Date: 8 March 2018

PRE-2014 LH3600-5 YOKE SERVICE BULLETIN

This service document provides instructions to inspect the Pre-2014 LH3600-5 yokes.

FIGURE 1

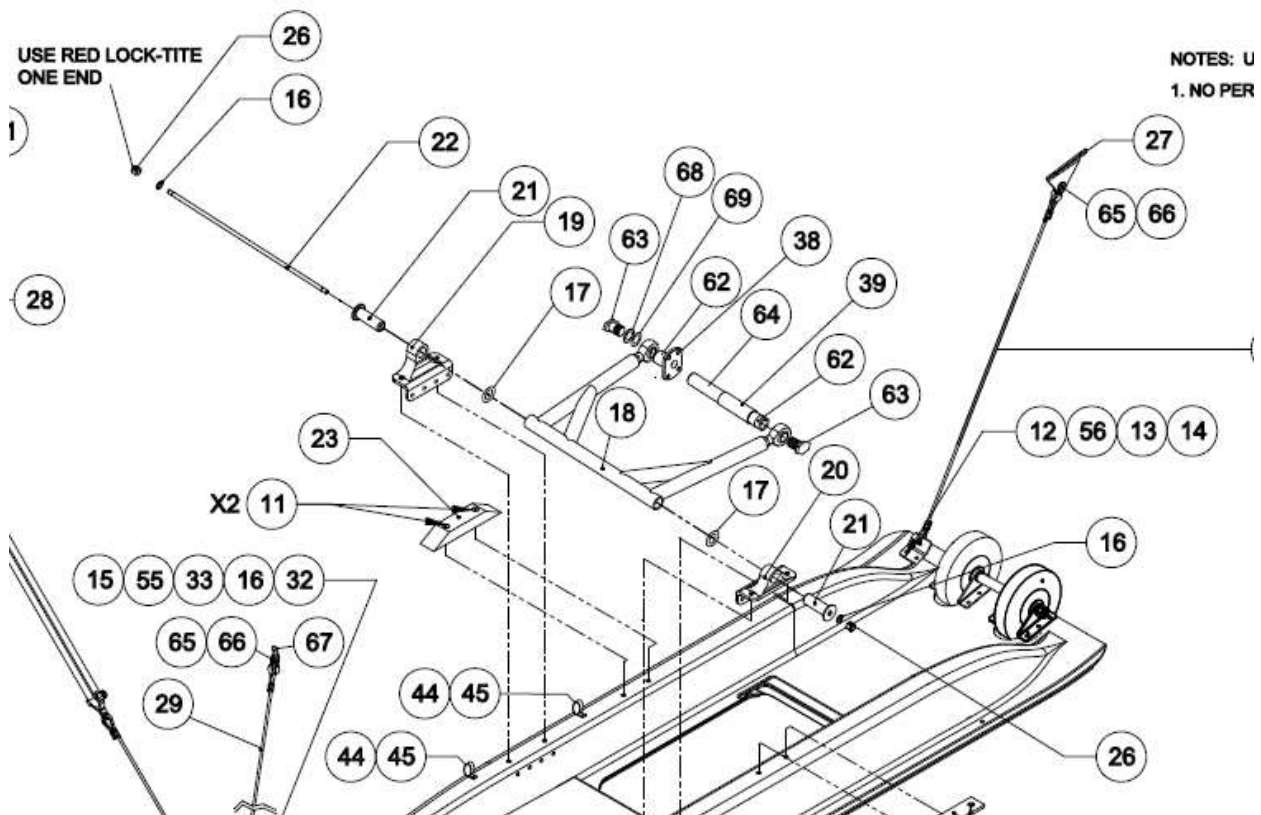
Airglas has received 4 reports of the LH4000 yoke (PN LH3600-5) of the welds shearing off the outboard arm of the yoke. The common thread between all occurrences is a heavy side load is applied to the skis. This sideways load appears to happen in a turn. In three cases, pilot reported to Airglas that they hit an obstruction in a turn.

The yokes Airglas manufactured up until 2014 were manufactured differently than current yoke. The older yokes were welded and then post heat-treated, followed by a mag-particle inspection. We have also seen some evidence that yokes may have been partially cracked, prior to final heavy side load occurrence. The yokes are powder coated, and this may be masking partial cracks.

5. The yokes will need to be inspected, using a magnetic particle inspection in accordance with AC43-13-1B, Chapter 5. Area of interest is the welds of the yokes.
6. The welds must be free of powder coat for proper inspection.

7. If no cracks are found, we recommend a 1" wide .100 4130N finger strap be welded on the outboard yoke arms. This will be an intermediate fix for the yoke. Weld strap with the use of AC43-13-1B, Chapter 4. Length of finger should allow a minimum of 2" of weld on the outboard attachment arm on both sides. **Intermediate finger straps repairs will eliminate further inspection requirements.**

8. The **best option** is to replace yokes with current generation yokes. Current generation yokes are of much higher strength and very resistant to high sideward shock loads. These yokes are not heat-treated and have internal build-ups. The lack of heat treatment makes them more ductile. This is the best option to prevent future cracking problems. Airglas will offer yokes at a low cost for 24 months from the date of this Service Bulletin.
